City of
Peterborough

COMMITTEE OF ADJUSTMENT

HEARING DATE: November 17, 2009

Staff Comments Regarding Files:

136 James Street

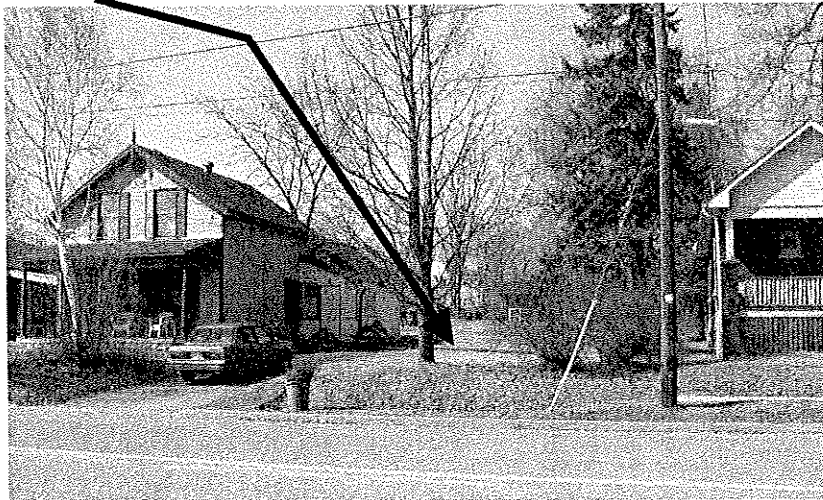
Once again staff would support the severance and easement described subject to the following conditions:

- 1) the owner entering into an agreement with the City to require that building plans be provided for approval by the Planner of Urban Design to ensure compatibility of building design with other buildings in the neighbourhood prior to issuance of a building permit. The agreement will also bind the owner with respect to the cost for the City to remove the City tree on the boulevard,
- 2) provision of reference plan describing the properties and easement to the satisfaction of the City Planner,
- 3) payment of a parks levy in the amount to be determined by the City's Parks Levy Review Committee, and
- 4) payment of a tree levy in the amount of \$137.00.

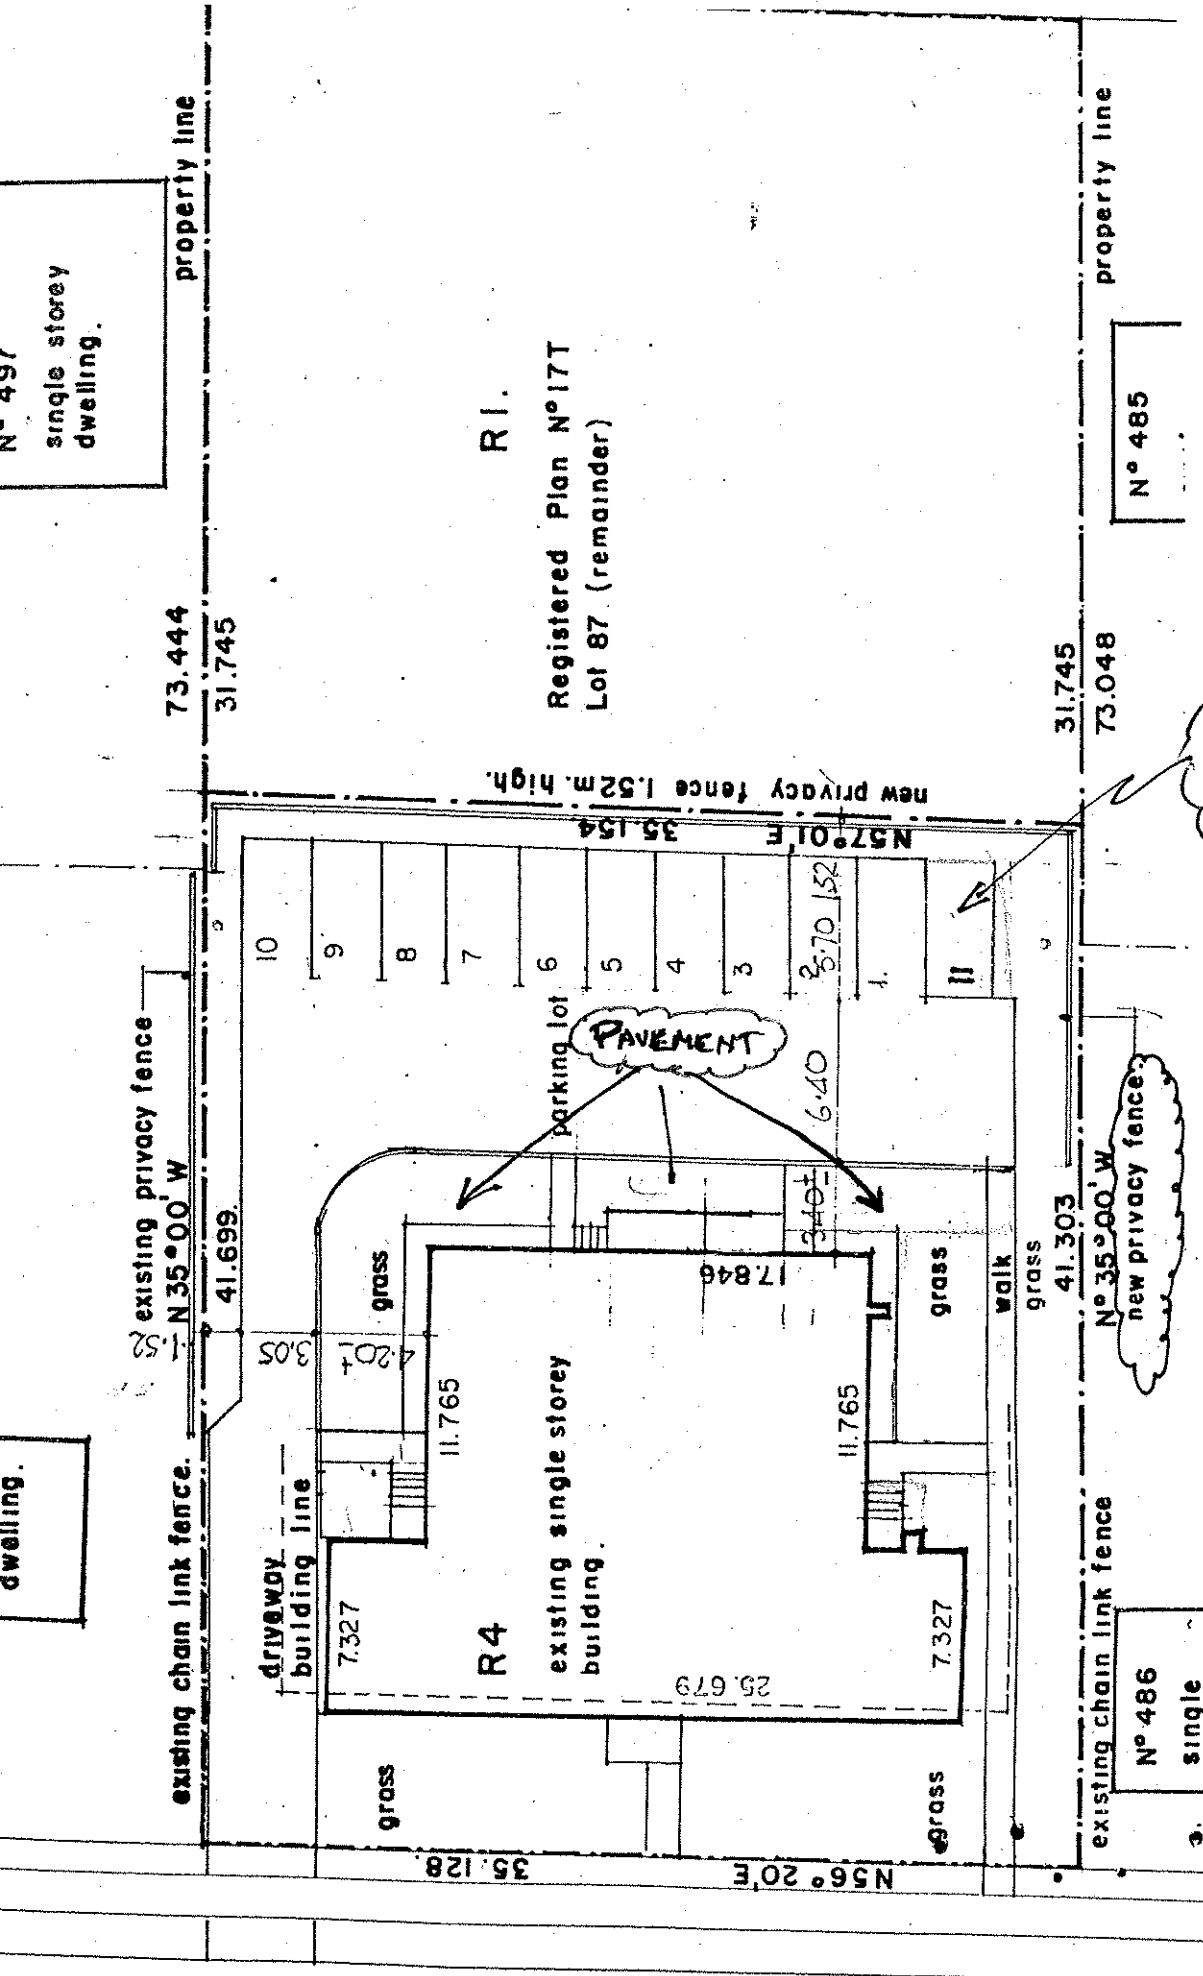
Staff considered the building form and how the proposed sixth unit would fit within the building without change and that adequate on site parking is available. Staff is therefore of the opinion that the impact of the variance to reduce the minimum lot area per dwelling unit from 275 to 244 square metres to permit one additional apartment would be minor. Considering the additional unit is a basement apartment, it should be verified that the height of the ceiling of the basement apartment is one metre above grade.

Considering the relief sought from the minimum distance of a vehicle movement area or parking space from a window of a habitable room, staff would suggest the Committee could consider the relief from the vehicle movement area (driveways) but would not support the relief regarding the parking area. It should be noted that no parking area is located within 20 metres of a window of a habitable room.

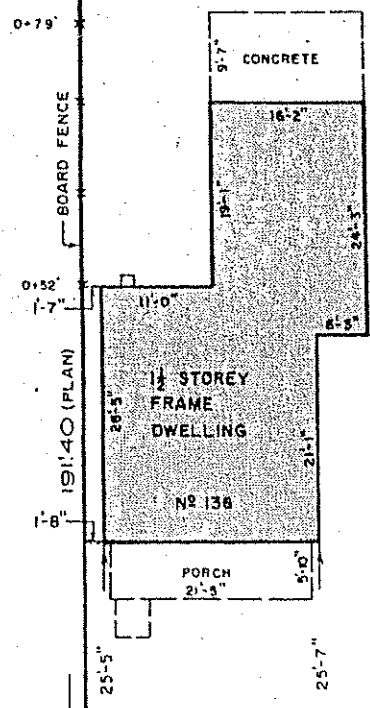
Consent is requested to convey the easterly 11.16 metres (36 ft) of the subject property together with a 1.8 metre wide by 1.8 metre deep easement over the south east corner of the retained property to create a new lot for development of a single unit dwelling and accommodate the location of an existing sewer service to the new lot.

The proposed severance has been requested and granted on two previous occasions and variances have been granted to facilitate the severance resulting in two lots with a minimum width of 11.16 metres (36 ft) as shown on Exhibit C. Due to unfortunate personal circumstances, the owner has been unable to fulfil the conditions associated with the consents granted and they have lapsed twice.

EXHIBIT **D**
 SHEET **1** OF **1**

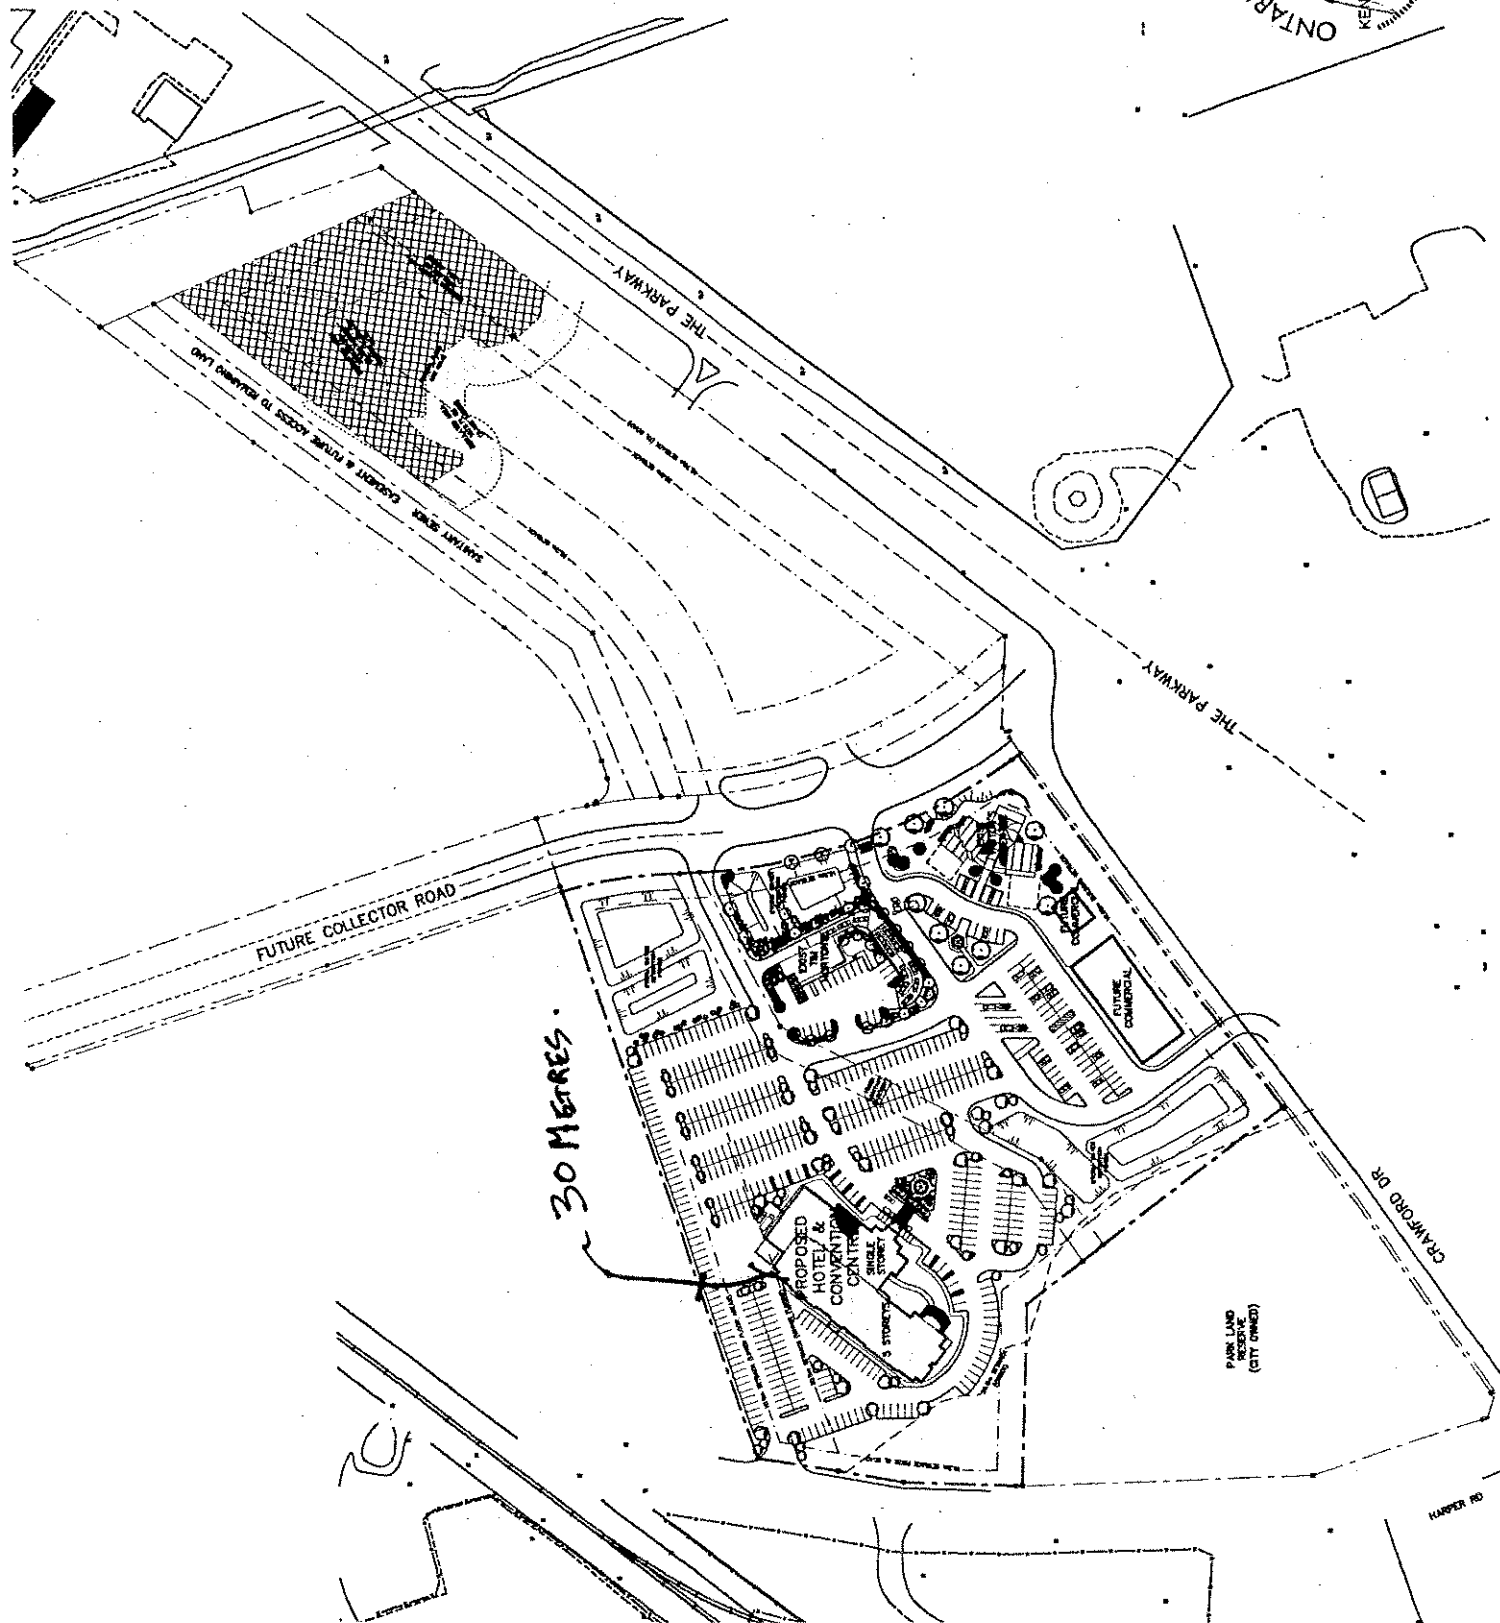
Because both zoning districts are applied to the subject property, there is the development potential for a building higher than two storeys on the property. Exhibit D illustrates the proposed location of the five storey building. The portion of the building that would be five stories in height is located 30 metres from the north lot line.

Considering the existing development and the zoned development potential of the surrounding land, Staff is of the opinion that the impact of granting the variance would be minimal and would have no objection to the Committee granting the variance as described provided that the minimum building setback from any lot line to any portion of the building exceeding two storeys in height is 30 metres. Staff would also suggest that the Committee grant the variance with a condition that if a permit for constructing the building is not issued by January 2012 the decision shall lapse.
